**STANNAH LIFTS TECHNICAL BULLETIN  
SYSTEM 21 LIFTS MANUFACTURED PRIOR TO 1995**

## Stannah Lifts Technical Bulletin

Issue No:E 11

System 21 lifts. Manufactured prior to 1995.

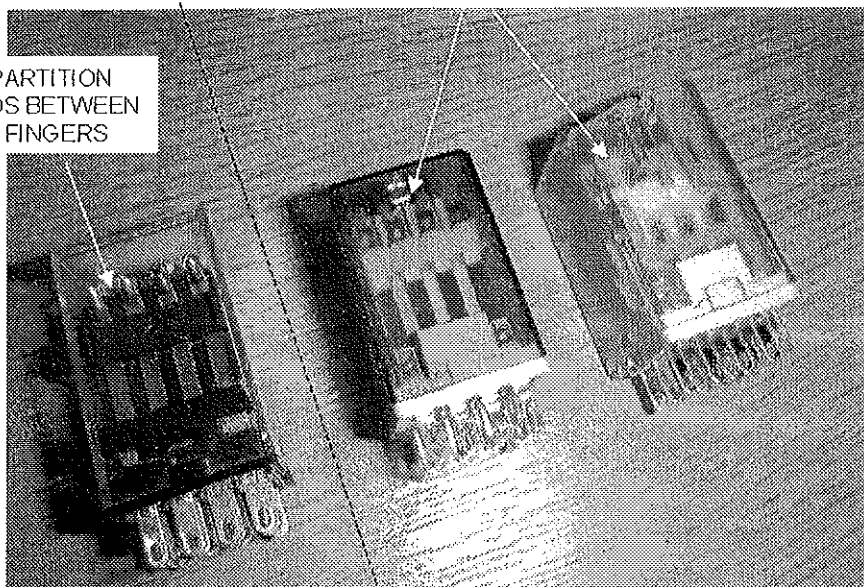
We have recently experienced a fault that occurred on a 12 year old traction lift, fitted with a Generation 1 controller. The ACR relay was found to have a short circuit within the relay connecting pins 9 and 10. The effect of the fault caused the gate lock circuit to be bypassed and created the possibility for the lift to travel with the doors open under certain test control conditions.

Through investigation and risk assessment we have identified that this fault has occurred on a very early version of IMO relay that may be found on lifts manufactured before 1995 (this is identified within the door of the control cabinet). The later versions, supplied by IMO, include additional arcing shields at the top of the 'fingers' that reduce the risk of this fault ever occurring. Therefore we request that at the next available service visit, any lift, hydraulic or traction that still contain an ACR relay of the 'older style' should be replaced with a newer version of relay. Please see attached diagram for further information on identification of relay.
